ZONING CONDITIONS FOR THE MERRITT RESERVE

CONSTRUCTION DRAWINGS FOR MERRITT RESERVE

PROJECT NUMBER = CID-25-XX

CU-201 PLAN & PROFILE

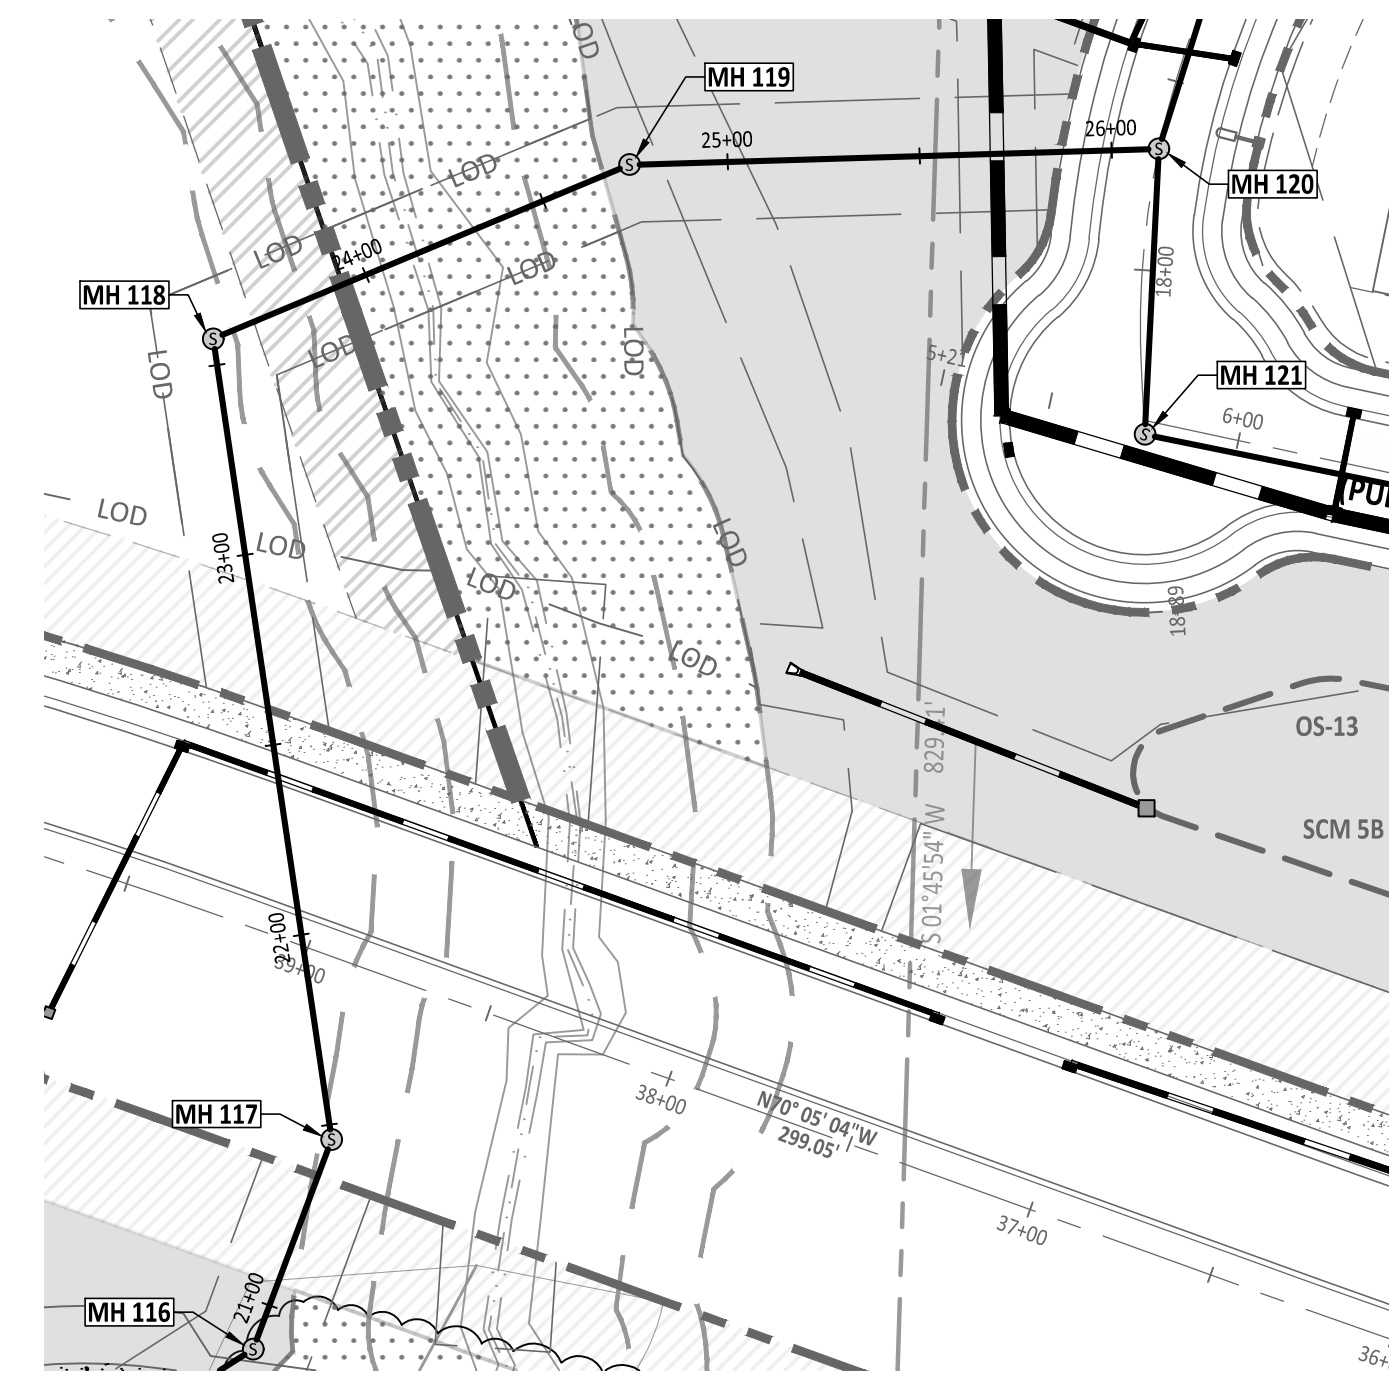
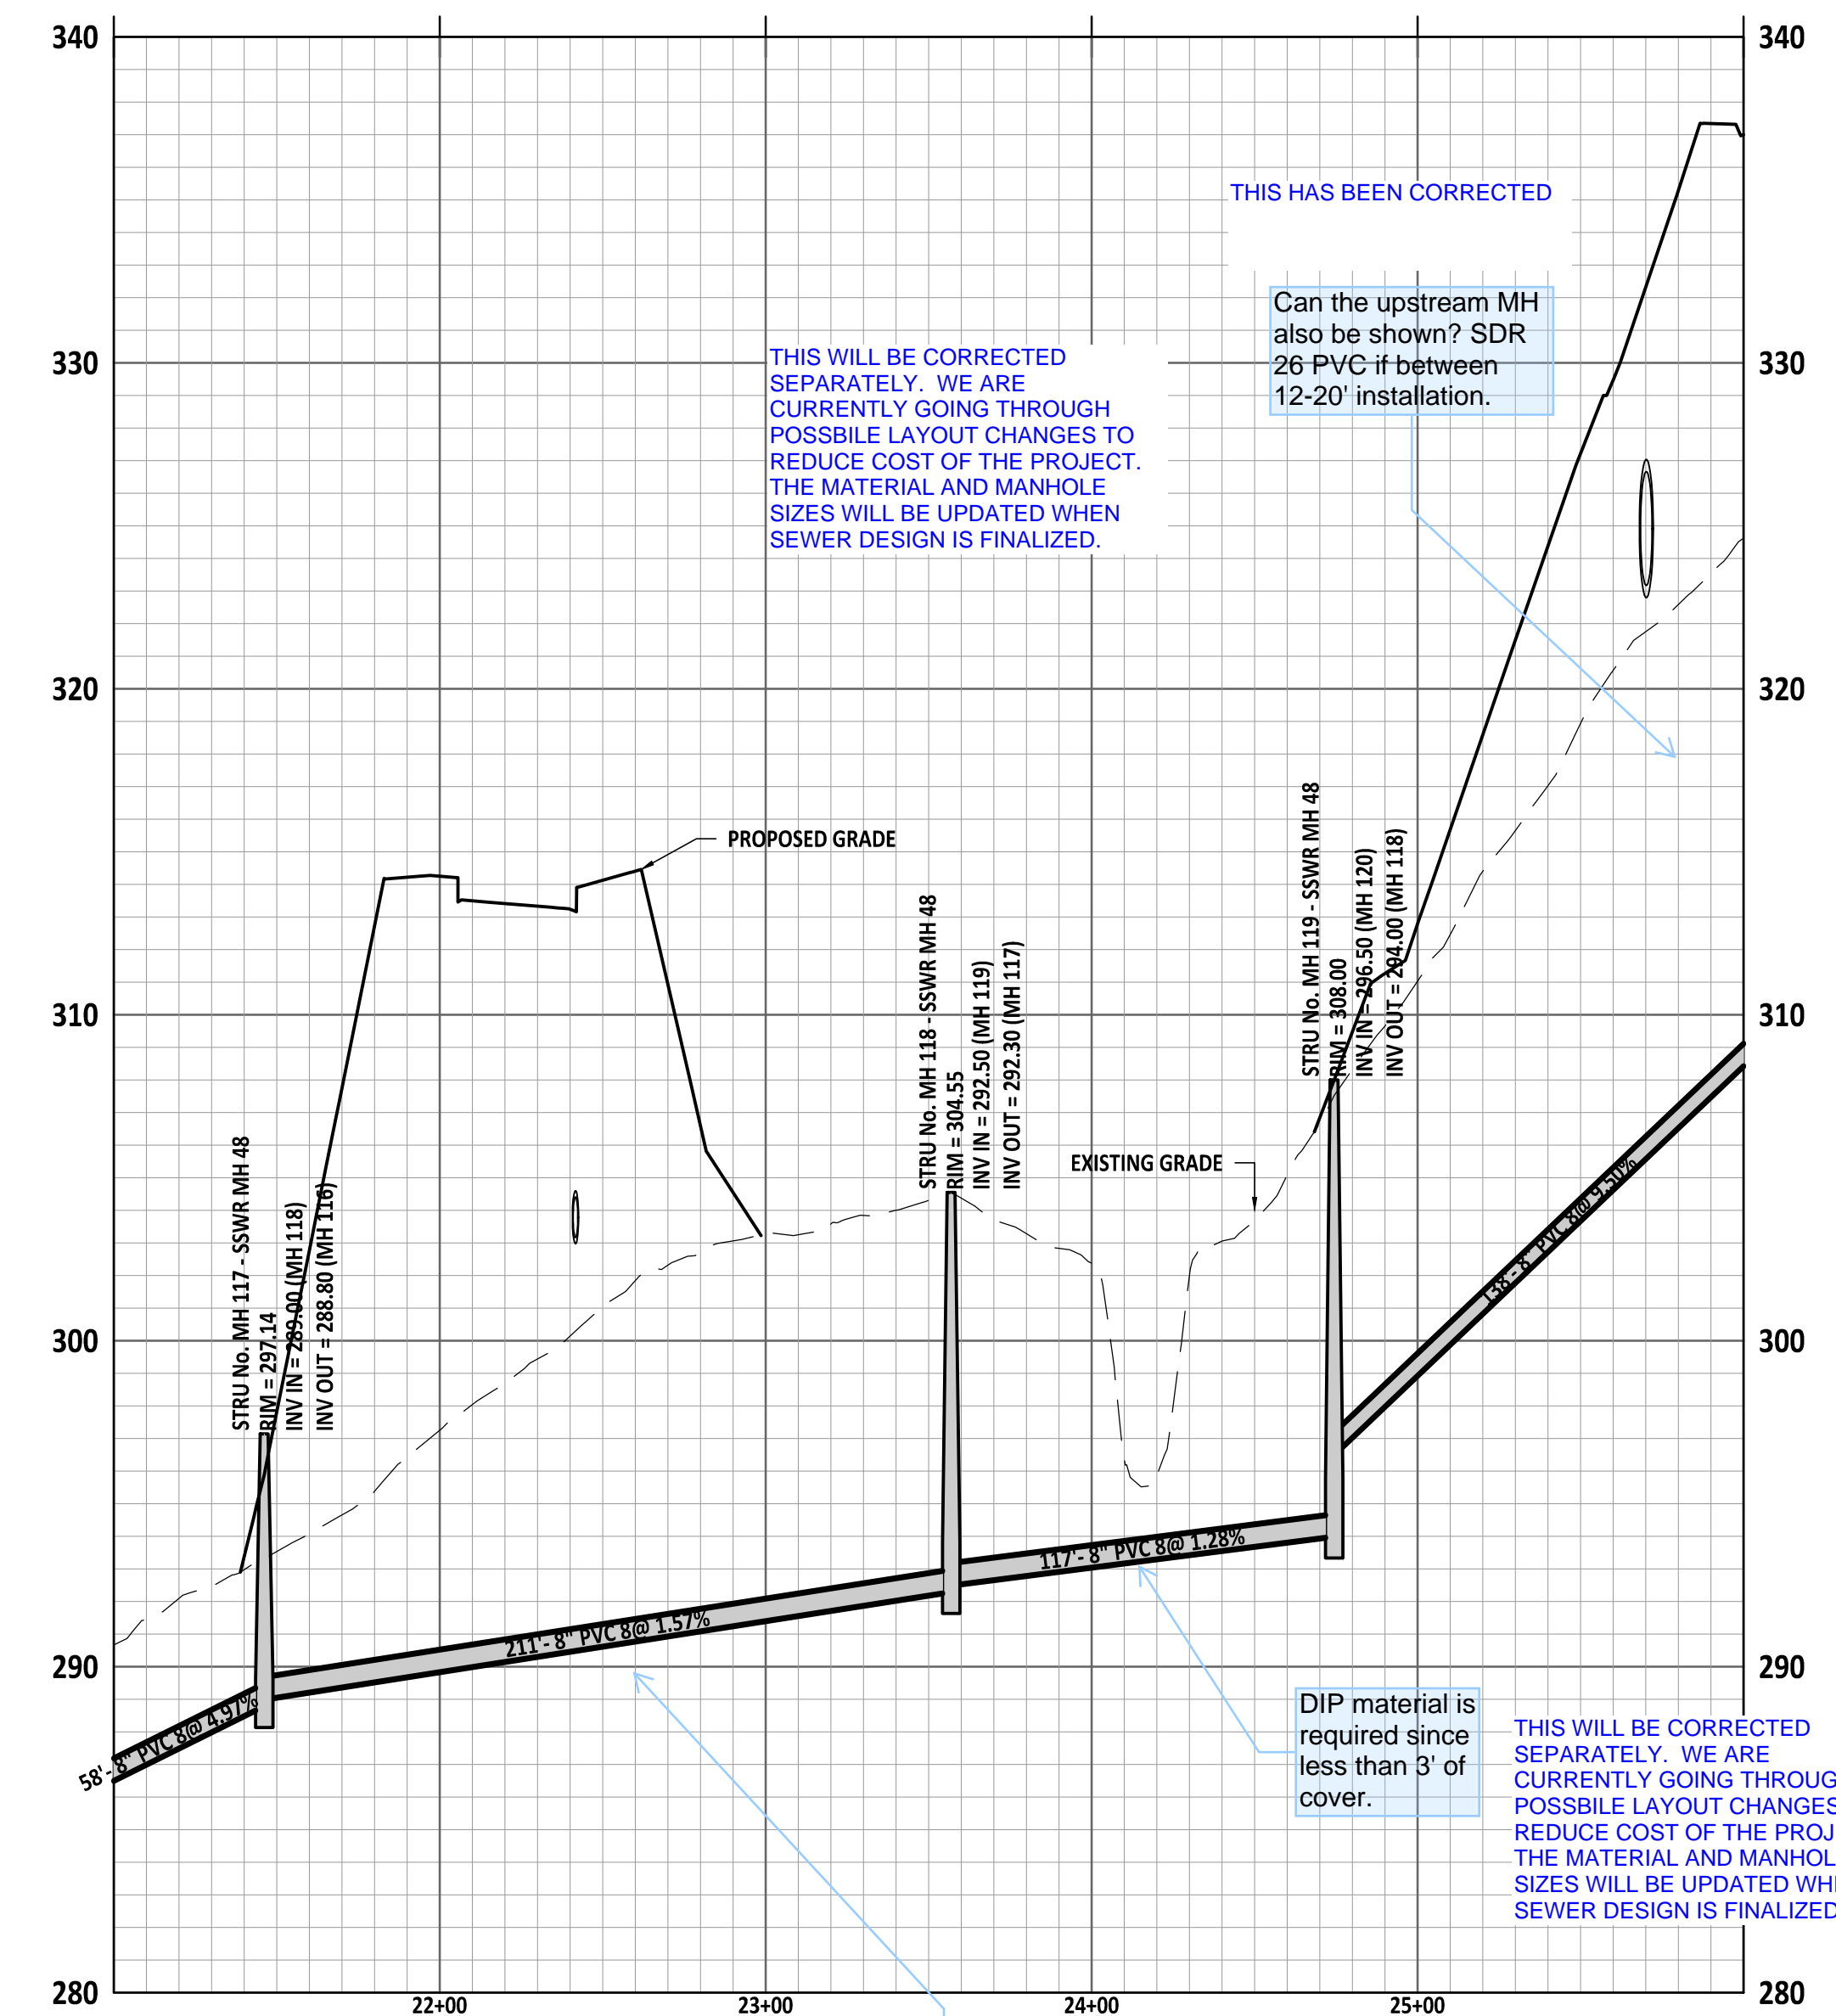
Must be DIP material at this depth. In fact, this main should also be installed within a casing at this depth for future maintenance.

Please call out all MH dia. If more than 12' installation depth, MHs must be 5' dia. If greater than 20' MHs must be 6' dia.

Try to get this installation less than 20' if possible, if absolutely not possible, DIP is required.

THIS WILL BE CORRECTED SEPARATELY. WE ARE CURRENTLY GOING THROUGH POSSIBLE LAYOUT CHANGES TO REDUCE COST OF THE PROJECT. THE MATERIAL AND MANHOLE SIZES WILL BE UPDATED WHEN SEWER DESIGN IS FINALIZED.

THIS WILL BE CORRECTED SEPARATELY. WE ARE CURRENTLY GOING THROUGH POSSIBLE LAYOUT CHANGES TO REDUCE COST OF THE PROJECT. THE MATERIAL AND MANHOLE SIZES WILL BE UPDATED WHEN SEWER DESIGN IS FINALIZED.

THIS WILL BE CORRECTED SEPARATELY. WE ARE CURRENTLY GOING THROUGH POSSIBLE LAYOUT CHANGES TO REDUCE COST OF THE PROJECT. THE MATERIAL AND MANHOLE SIZES WILL BE UPDATED WHEN SEWER DESIGN IS FINALIZED.

THIS WILL BE CORRECTED SEPARATELY. WE ARE CURRENTLY GOING THROUGH POSSIBLE LAYOUT CHANGES TO REDUCE COST OF THE PROJECT. THE MATERIAL AND MANHOLE SIZES WILL BE UPDATED WHEN SEWER DESIGN IS FINALIZED.
